STAFF REPORT: 5/12/2021 MEETING PREPARED BY: J. ROSS

APPLICATION NUMBER: 21-7219

ADDRESS: 1700 SEYBURN

SCOPE: REPLACE VINYL WINDOWS AT REAR BAY WITH NEW VINYL WINDOWS; INFILL ONE WINDOW OPENING AT REAR ELEVATION

Proposed condition at rear elevation bay.

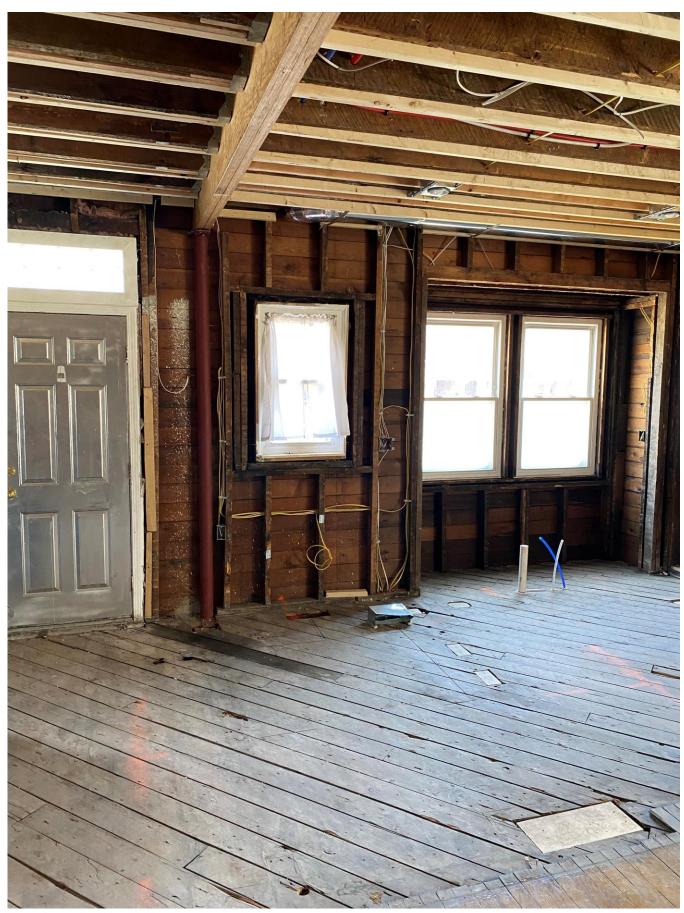
- The submitted drawing depicts "proposed" conditions. It is clear to staff that the applicant is installing new windows, new 24"-high vertical trim elements, and a 10" high wood element beneath the new windows and trim. It is not clear if the project proposes to remove any existing elements at the bay window
- It is unclear to staff how the new 24"-high vertical trim elements and the 10" high wood element beneath the new windows and trim will be finished (painted, covered with stucco, etc.)

- As noted above, the home's current vinyl windows represent violation as there is no record that they were approved by the HDC
- It is HDC staff's opinion that vinyl windows are not compatible with the building's historic character
- The building is located at an intersection. The rear bay window is therefore highly visible and represents a distinctive character-defining feature of the home. It is staff's opinion that the vinyl windows proposed for installation at the bay window do not meet the Standards.
- As stated above, it is unclear to staff how the new 24"-high vertical trim elements and the 10" high wood element beneath the new windows and trim will be finished (painted, covered with stucco, etc.)

- None of the historic wood and stucco trim located within the bay window shall be removed. Rather, areas of deteriorated shall be repaired in kind where necessary
- The existing three vinyl windows which were installed without HDC approval shall be removed and replaced with three new 24"x36" wood or wood, aluminum-clad windows
- The applicant's final permit documents shall be revised to accurately reflect the manner in which the new 24"-high vertical trim elements and the 10" high wood element beneath the new windows and trim will be finished
- The applicant's final permit documents shall be revised to accurately reflect the Commission's approval. The documents shall be submitted to HDC staff for review and approval prior to the issuance of the permit

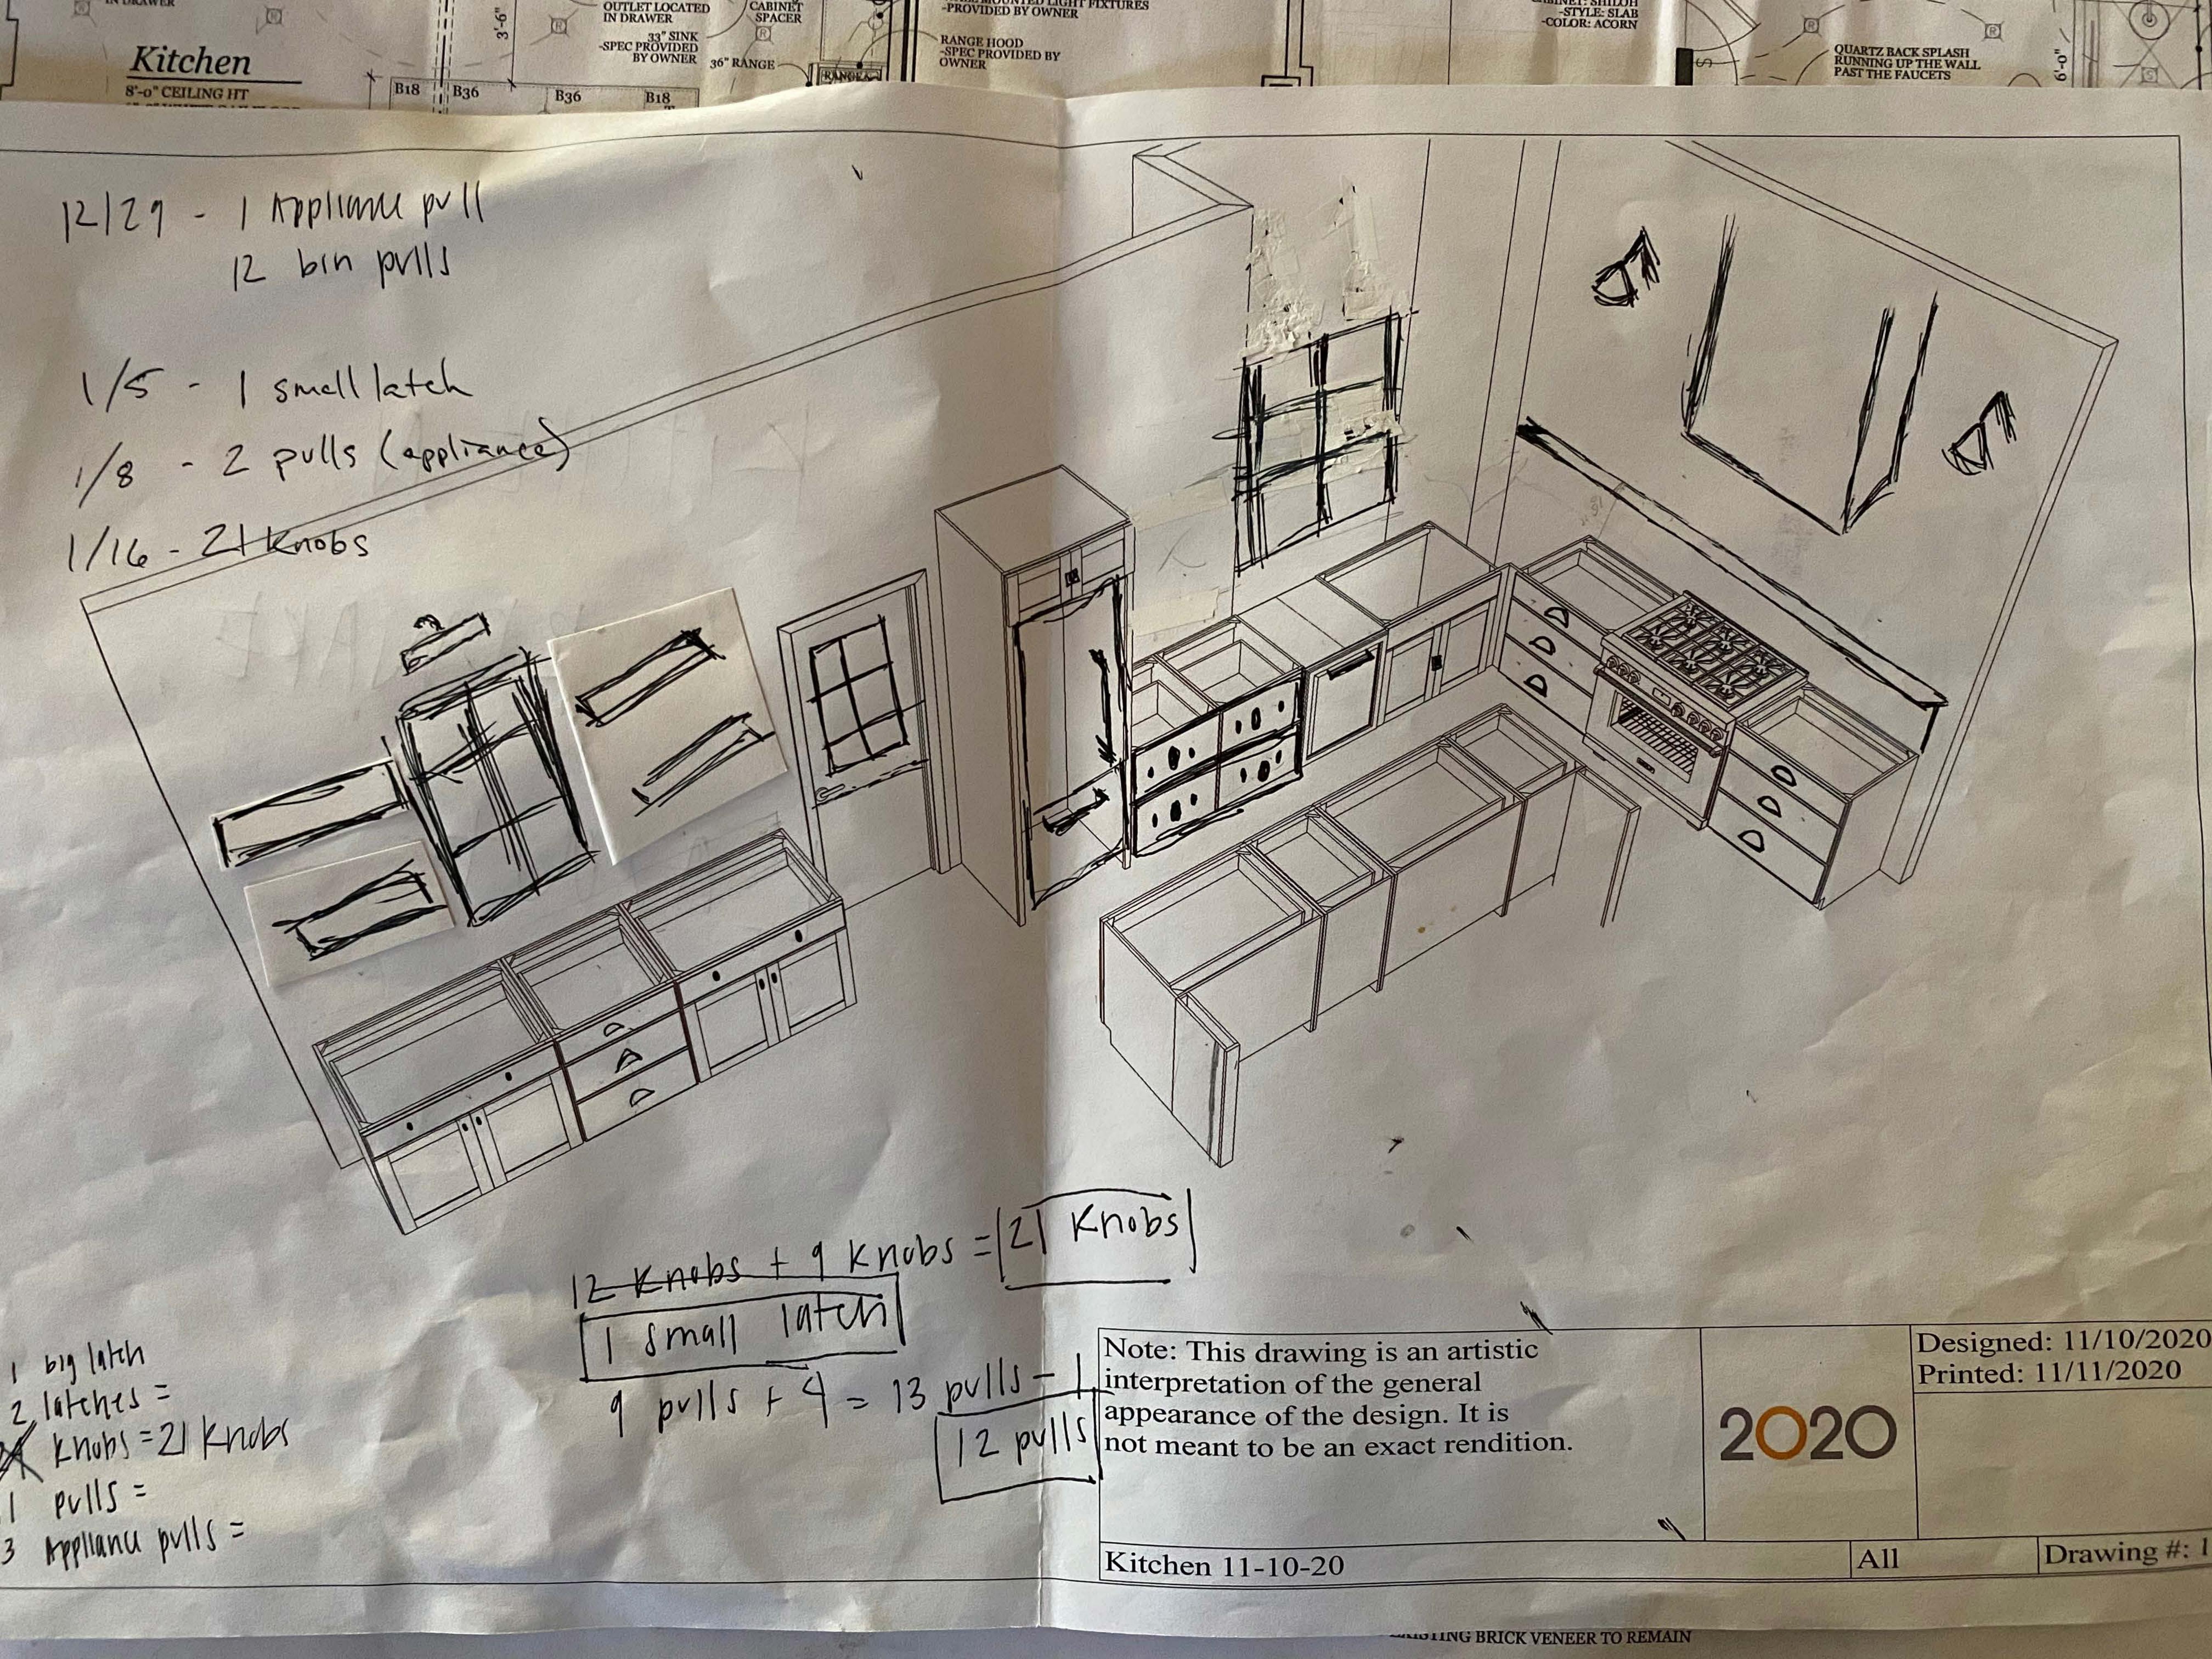
Bay window - current exterior trim dimensions 82x62" // proposed dimensions 82x52" - (2) 34x56" white vinyl windows to be replaced by (3) American Craftsman double-hung 24x46" white vinyl windows with (2) 5x52" white mullions- Installing three vinyl windows into the existing vinyl window opening on the back of the house, located in the kitchen. Work is being done to accommodate the kitchen counter and sink. All exterior trim to match the existing throughout the exterior of the house.

Small window - 28x46" window on the rear of house to be filled in to match existing brick. Work is being done to accommodate kitchen cabinetry.
